APPLICATION NO. FILING DATE		FIRST NAMED INVENTOR	ATTORNEY DOCKET NO.	CONFIRMATION NO.	
10/789,388 02/28/2004		John P. Kallestad	DC1-001	4950	
7:	590 ' 01/27/2006		EXAM	INER	
Brian C. Kelly, Ltd.			KAYES, SEAN PHILLIP		
Attorney at Law 555 South Center St.		OIPE	ART UNIT	PAPER NUMBER	
Reno, NV 89	501	4	2841	· -	
		FEB 0 6 2006	DATE MAILED: 01/27/200	6	
		Page 1

Application No.	Applicant(s)			
	10/789,388	KALLESTAD, JOHN P. (AM)			
Office Action Summary	Examiner	Art Unit			
	Sean Kayes	2841			
The MAILING DATE of this communication ap Period for Reply	pears on the cover sheet with the c	orrespondence address			
A SHORTENED STATUTORY PERIOD FOR REPL WHICHEVER IS LONGER, FROM THE MAILING E - Extensions of time may be available under the provisions of 37 CFR 1. after SIX (6) MONTHS from the mailing date of this communication. - If NO period for reply is specified above, the maximum statutory period - Failure to reply within the set or extended period for reply will, by statut Any reply received by the Office later than three months after the mailir earned patent term adjustment. See 37 CFR 1.704(b).	DATE OF THIS COMMUNICATION 136(a). In no event, however, may a reply be tim will apply

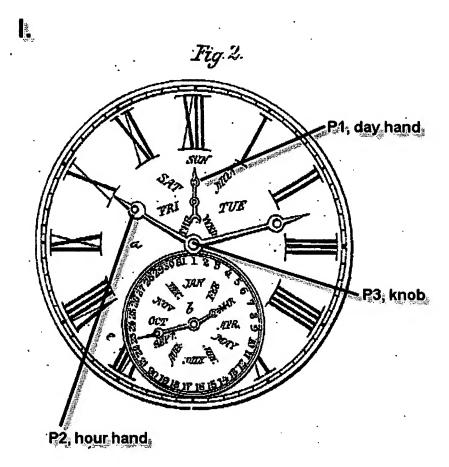
- (b) the invention was patented or described in a printed publication in this or a foreign country or in public use or on sale in this country, more than one year prior to the date of application for patent in the United States.
- 4. Claims 1-4 and 7-9 are rejected under 35 U.S.C. 102(b) as being anticipated by Carter (US 39883.)
- 5. With respect to claim 1 Carter discloses a clock comprising means for actuating a hand to indicate day of the week (the driving means behind the movement of P1, picture I, shown in figure 1 as item C.)

- 6. With respect to claim 2 Carter discloses a clock as described in claim 1 wherein said means for actuating said hand (P1) comprises at least one gear (see figure 1) having a rotation cycle of 7 days.
- 7. With respect to claim 3 Carter discloses a clock as described in claim 2 wherein said gear communicates with at least one other gear (gear connected to hand P2) that completes 14 revolutions in said cycle.
- 8. With respect to claim 4 Carter discloses a clock as described in claim 3 wherein said other gear actuates at least one hand (P2) to indicate hours.

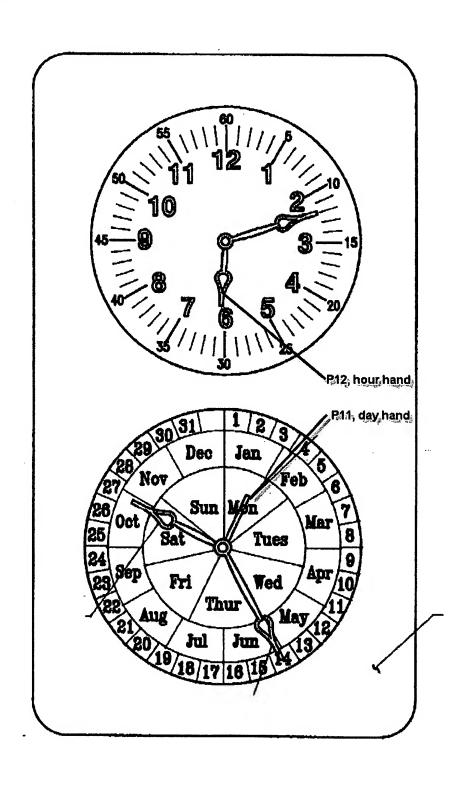
- 10. With respect to claim 8 Carter discloses a clock as described in claim 1 wherein said adjustment means comprises at least one knob (the time can be adjusted by rotating the displayed hand about the knob P3, picture I.)
- 11. With respect to claim 9 Carter discloses a clock as described in claim 1 wherein said adjustment means comprises at least one knob to adjust said day indicator (the hour hand, P2, is connected to the day hand, P1, and rotating the hour hand to adjust the time would in turn rotate and adjust the day hand, P1.)
- 12. Claims 1-9 are rejected under 35 U.S.C. 102(b) as being anticipated by Evans (US 6359840.)
- 13. With respect to claim 1 Evans discloses a clock comprising means for actuating a hand (P11, picture II.) to indicate day of the week.

- 14. With respect to claim 2 Evans discloses a clock as described in claim 1 wherein said means for actuating said hand comprises at least one gear having a rotation cycle of 7 days (the gear that drives P11.)

- 15. With respect to claim 3 Evans discloses a clock as described in claim 2 wherein said gear communicates with at least one other gear that completes 14 revolutions in said cycle (the gear that drives P12.)

- 16. With respect to claim 4 Evans discloses a clock as described in claim 3 wherein said other gear actuates at least one hand to indicate hours (P12.)

- 19. With respect to claim 7 Evans discloses a clock as described in claim 1 further comprising means for adjusting time (item 36, figure 6) indicated by said clock.

- 20. With respect to claim 8 Evans discloses a clock as described in claim 1 wherein said adjustment means comprises at least one knob (item 36 figure 6.)

- 21. With respect to claim 9 Evans discloses a clock as described in claim 1 wherein said adjustment means comprises at least one knob (36 figure 6) to adjust said day indicator.

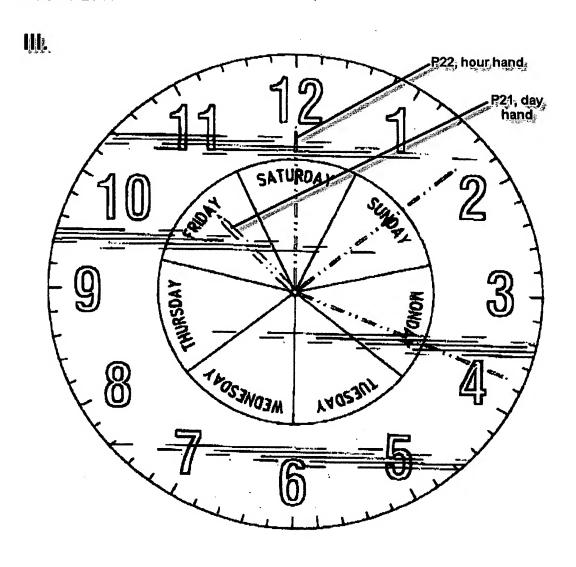
- 23. With respect to claim 1 Kallestad discloses a clock comprising means for actuating a hand (P21, picture III.) to indicate day of the week.
- 24. With respect to claim 2 Kallestad discloses a clock as described in claim 1 wherein said means for actuating said hand comprises at least one gear having a rotation cycle of 7 days (the gear that drives P21.)
- 25. With respect to claim 3 Kallestad discloses a clock as described in claim 2 wherein said gear communicates with at least one other gear that completes 14 revolutions in said cycle (the gear that drives P22.)
- 26. With respect to claim 4 Kallestad discloses a clock as described in claim 3 wherein said other gear actuates at least one hand to indicate hours (P22.)
